UNITED STATES PATENT AND TRADEMARK OFFICE

APPLICATION NO.	FILING DATE	FIRST NAMED INVENTOR	ATTORNEY DOCKET NO.	CONFIRMATION NO.
09/914,305	08/27/2001	Tiziano Dall'Occo	US 18024	3720

Office Action Summary

DETAILED ACTION

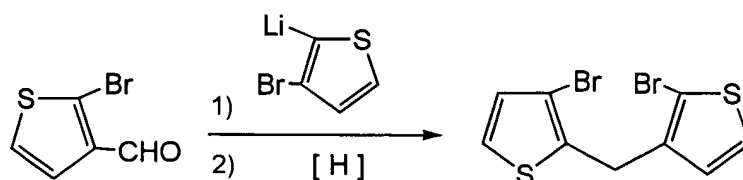
The claim is drawn to the synthesis of compound (VII) in which substituents R^7 and R^8 are not hydrogen. The basic elements of the claim, depicted in reaction sequence format, are shown in the scheme below (substituents R^7 , R^8 , and R^9 omitted in precursors for clarity).

While the reference does not show specifically an example for the synthesis of the 7*H*-cyclopenta[1.2*b* : 4.3-*b'*]dithiophene isomer of the present claims, or substituted derivatives thereof, one having skill ordinary skill in the art would have found it obvious to arrive at the present claims because the general synthetic steps are adequately disclosed in the reference.

It would be obvious to use the above reaction steps for the preparation of the 7*H*-cyclopenta[1.2*b* : 4.3-*b'*]dithiophene because this is discussed generally (see structure I) along with other cyclopentadithiophene isomers. One would be motivated to modify the coupling step shown in the reaction sequence on page 3382 (also referenced in *J. Org. Chem.* 1964, 29, 2455), because the lithiation method described in the current reference affords dithienylmethanes in much higher yield. Finally, one with skill in the art would recognize that simple alkyl substituents would not affect the mechanism of the above general reactions. Thus, one would find it obvious to use the same procedure to make substituted cyclopentadithiophenes with a reasonable expectation of success.
